CREMORNE STAGE 2 – PLANS

Referral comments

Planning Application No: PLN15/1176.01

Proposal: Amendment to planning permit for development
Site location: 2 Gough Street, Cremorne VIC 3121

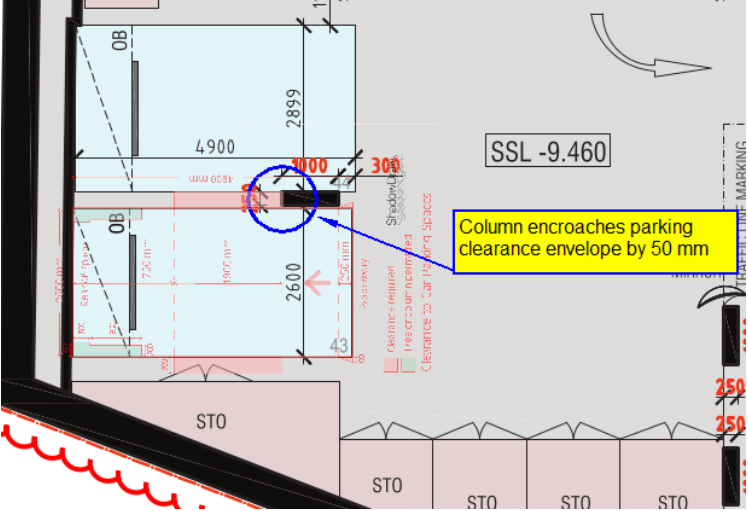
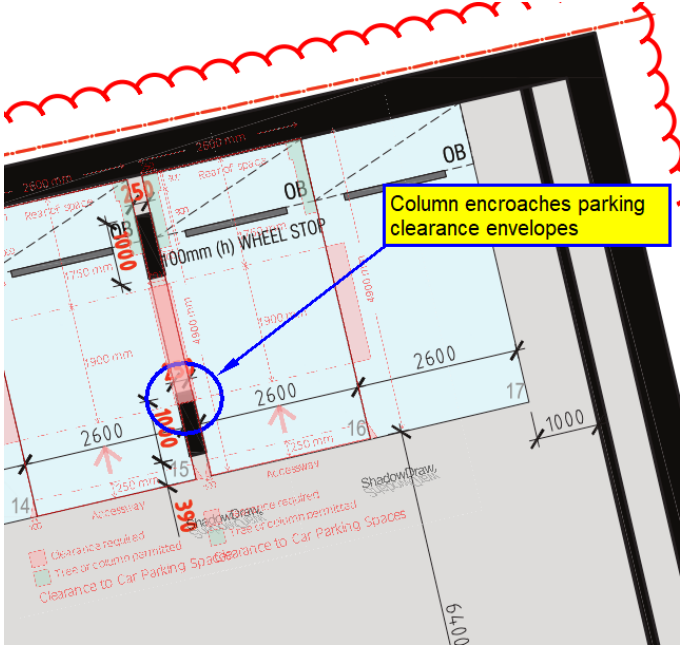
Small Car Spaces	The widths of the Small Car spaces satisfy AS/NZS 2890.1:2004.
Tandem Parking Sets	Tandem parking sets have minimum lengths of 10.3 metres and satisfy <i>Design standard 2</i> .
Aisles	Aisle widths range from 5.14 to 6.4 metres and satisfy <i>Table 2: Minimum dimensions of car parking spaces and accessways</i> of Clause 52.06-9.
Column Depths and Setbacks	Most columns have been positioned outside of the parking space clearance envelopes required by <i>Diagram 1 Clearance to car parking spaces</i> and Condition 1(ff), except for columns adjacent to the following spaces:

Spaces 43 (TP-166, TP-167 and TP-168) Space 38 (TP-169) Spaces 15 and 16 (TP-166, TP-167 and TP-168) Spaces 14 and 15 (TP-169).
Clearances to Walls	Clearances of no less than 300 mm have been provided to space adjacent to walls, and satisfy <i>Design standard 2</i> .
Blind Aisle Extensions	Blind aisle extensions of 1.0 metre have been provided and satisfy AS/NZS 2890.1:2004.

Item	Details
<p>Column Depths and Locations</p>	<p>The columns adjacent to the following spaces should be repositioned outside the parking space clearance envelopes:</p> <p>Spaces 43 (TP-166, TP-167 and TP-168) and space 38 (TP-169). Located at west corner of each basement level:</p>  <p>Spaces 15 and 16 (TP-166, TP-167 and TP-168) and spaces 14 and 15 (TP-169). Located at east corner of each basement level:</p> 
<p>Proposed On-street Parking</p>	<p>All references to proposed on-street parking are to be deleted. As per Condition 73 of the Permit, 'No parking restriction signs must be removed, adjusted, changed or relocated without approval or</p>
